ADDENDUM NO. 2

Date: November 2, 2021

Project: First and Second Floor HVAC and Electrical
Upgrades to Reading Administration Building

CE No.: 18-2767-2

FLOOR FINISH PLANS
ALL DIMENSIONS and EXISTING CONDITIONS shall be CHECKED and VERIFIED by the CONTRACTOR at the SITE.

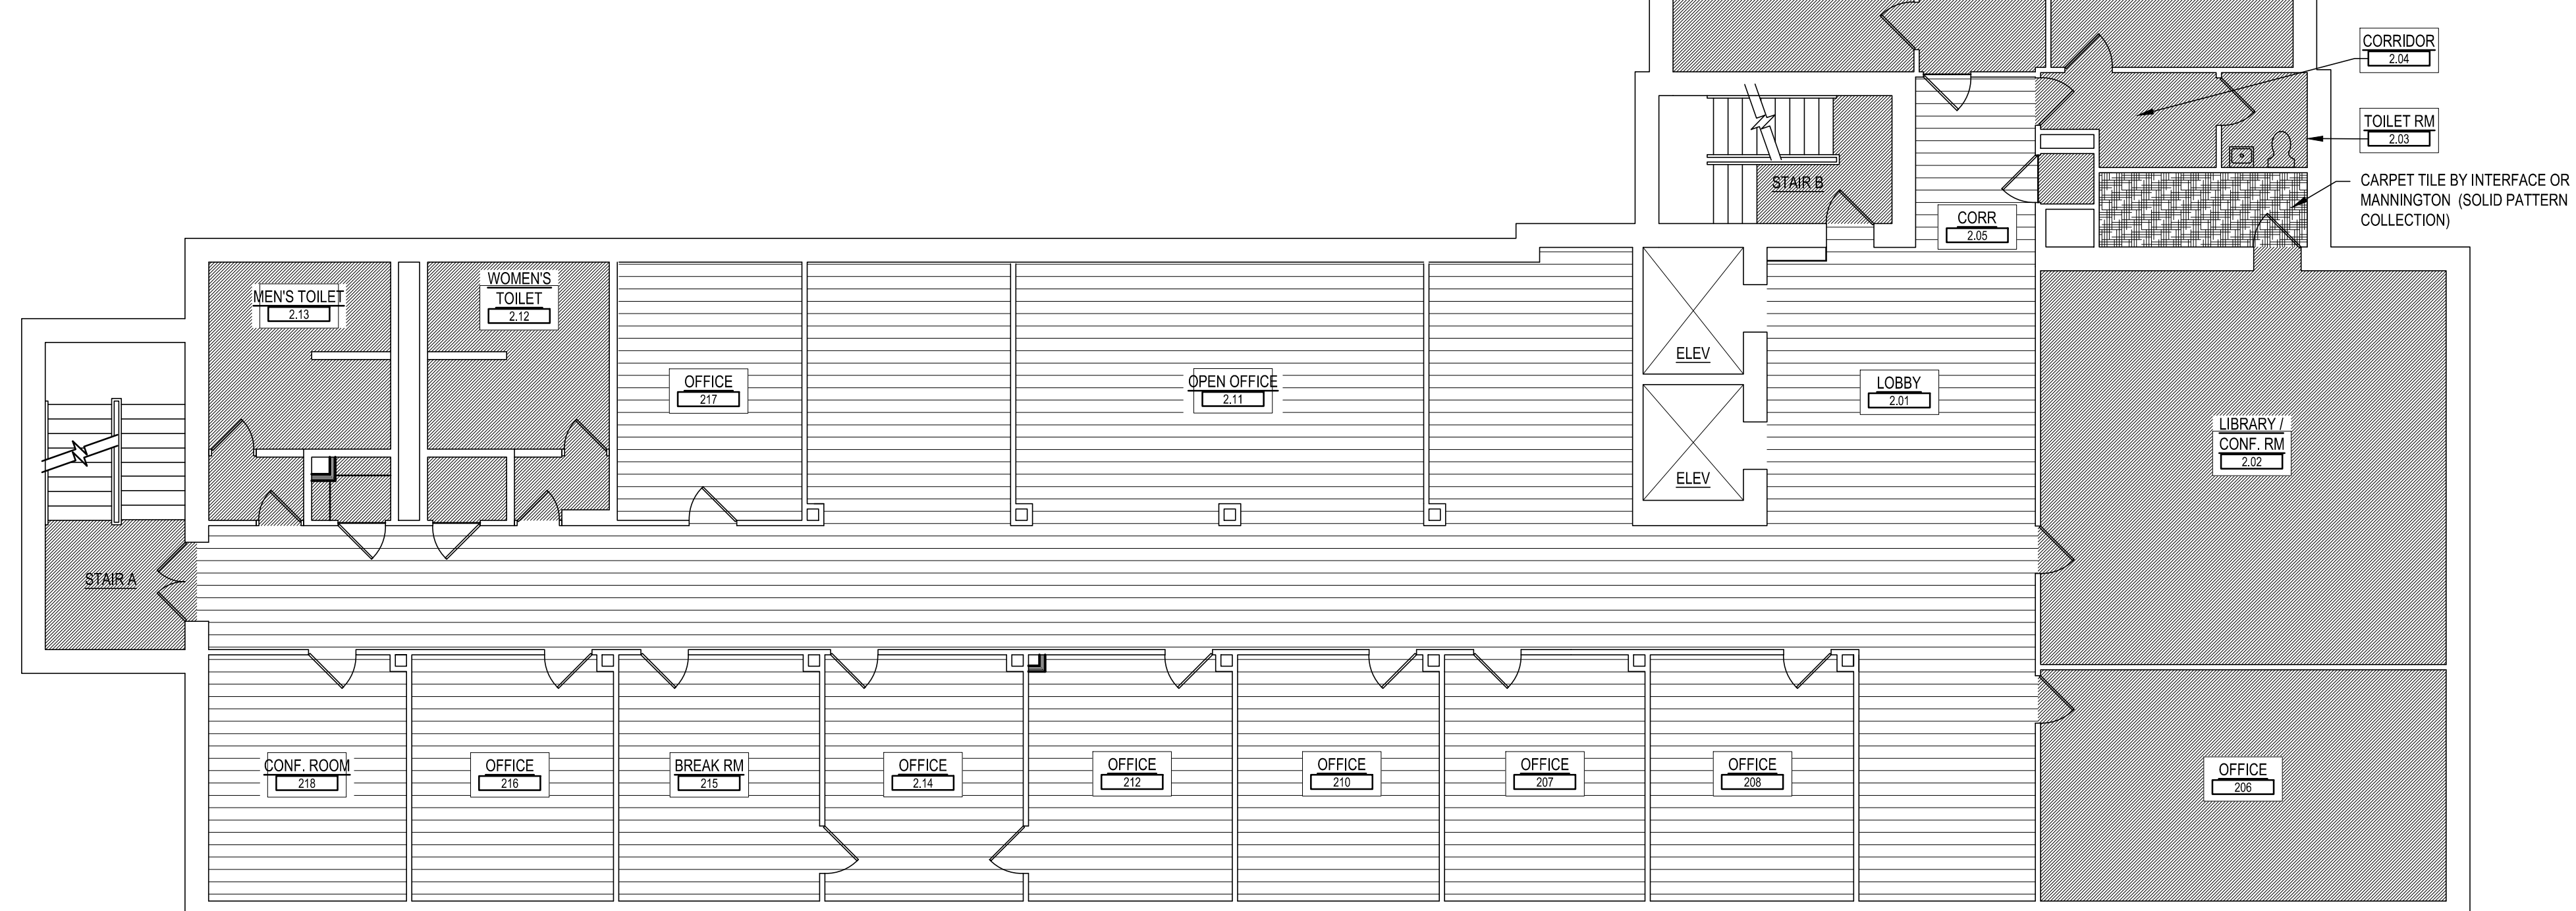
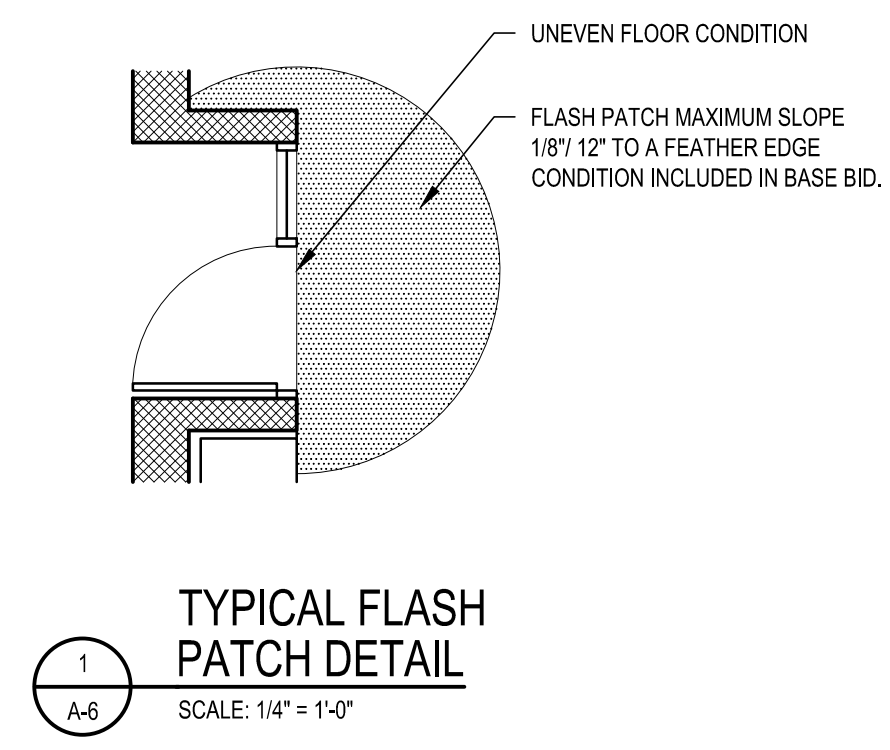
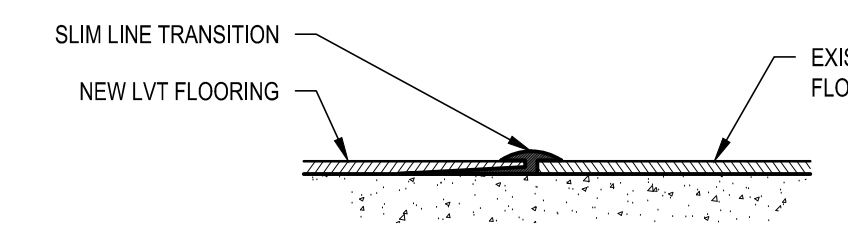
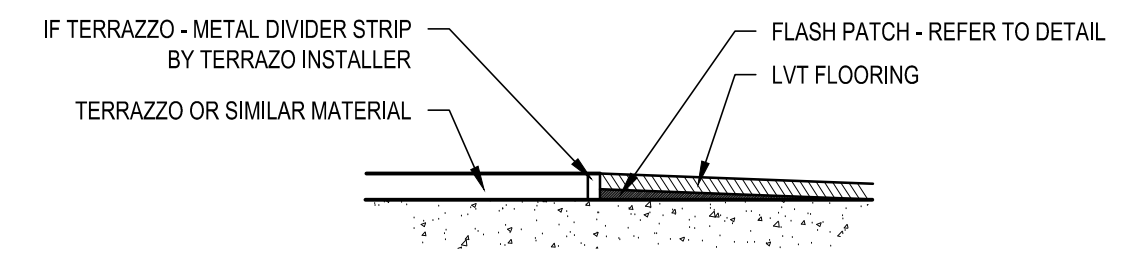
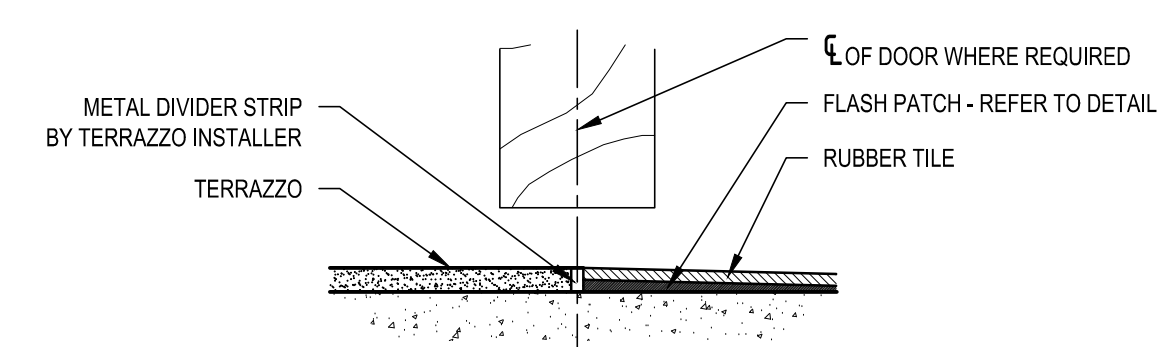
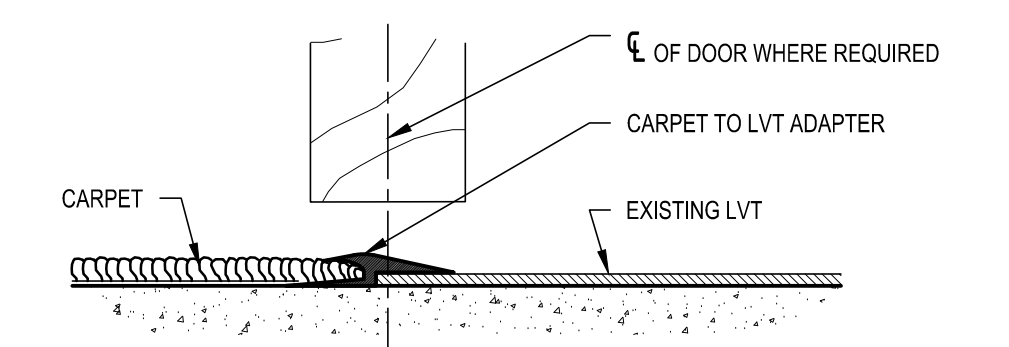
- 1.6 Refer to attached Drawing A-6, Floor Finished Plan for New Flooring. This drawing shall be added to the project documents.
- 1.7 Refer to attached sketch SKH-1 and contract drawing H-3. In Conference room 1.06 eliminate evaporator EVP-S1-11 and provide (2) two evaporators EVP-S1-11A and EVP-S1-11B and indicated-on sketch SKH-01. Modify ductwork and piping as indicated. Provide separate refrigerant piping (suction and liquid) from each evaporator to the branch selector box (BS-S1B). provide additional space temperature sensors as indicated.

SCALE: 1/8" = 1'-0"
 DATE: 11-01-21
 DWG. NO.: **SKH-3**

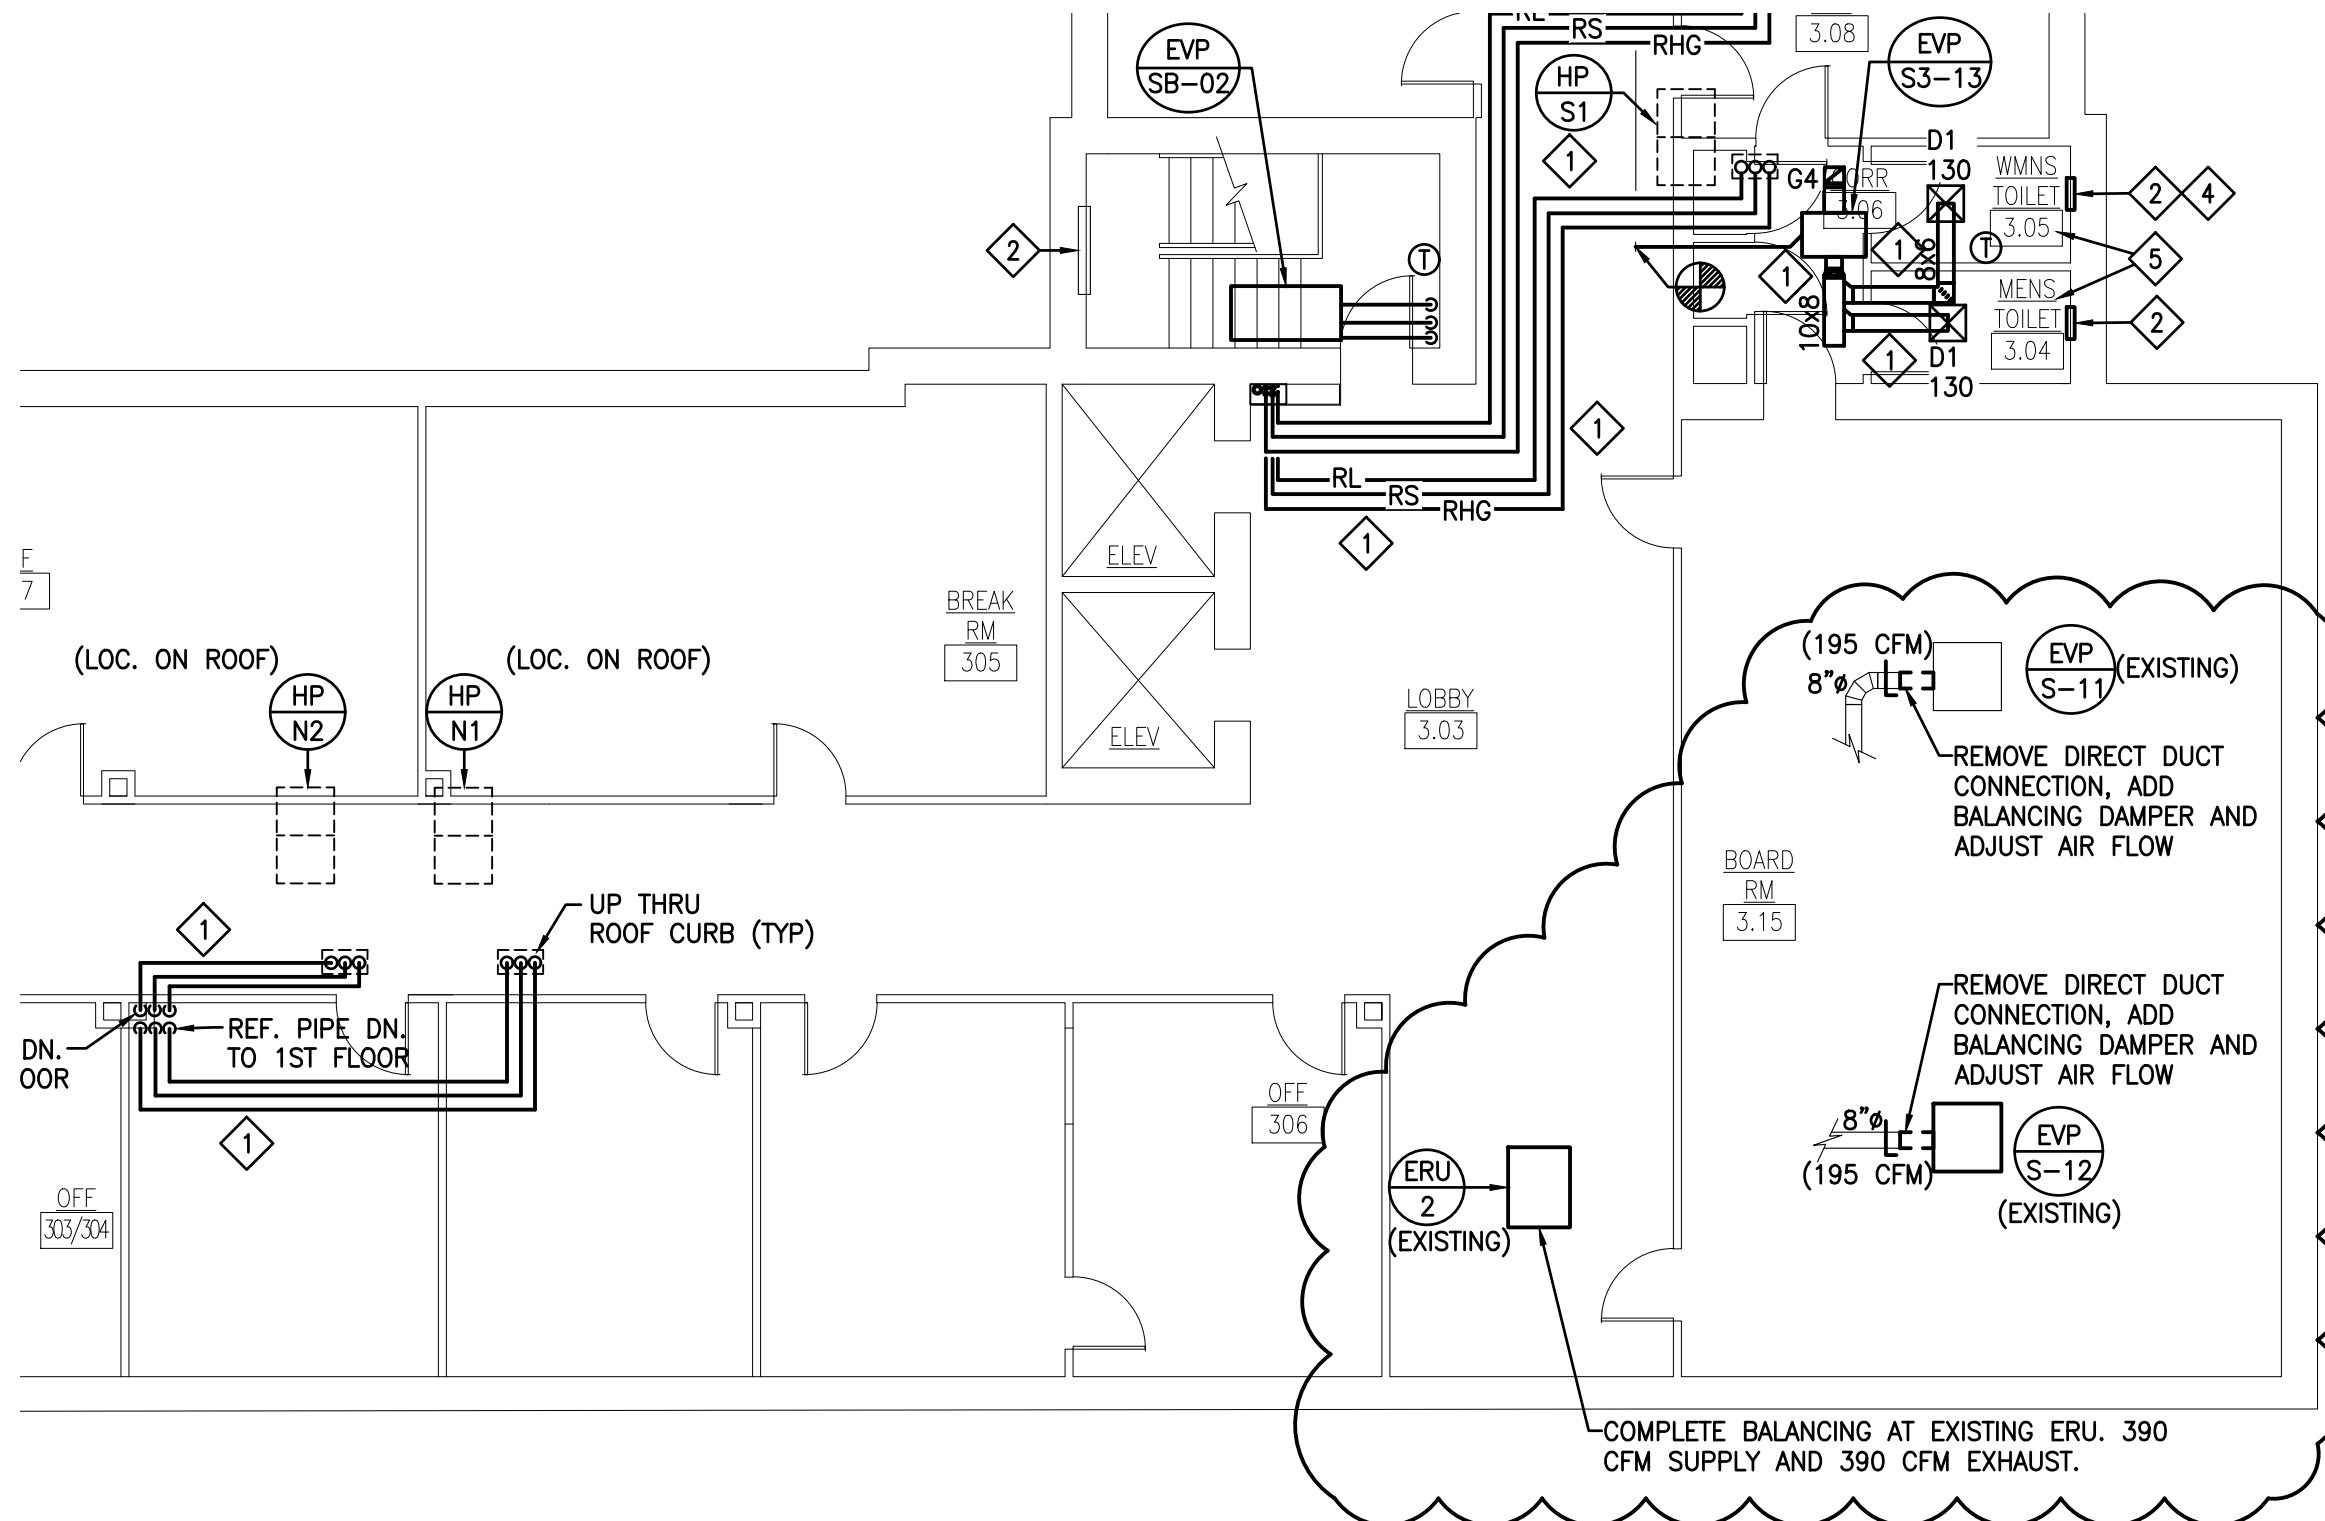
- 1.9 Refer to attached sketch SKH-3 and contract drawing H-5. Remove the direct duct connections to the existing evaporators EVP-S-11 and EVP-S-12 located in the Board Room. Provide new balancing dampers and adjust the air flows (cfm) as indicated. Adjust and record total supply and exhaust air flows, (390 cfm, each) for existing energy recovery unit (ERU-2).
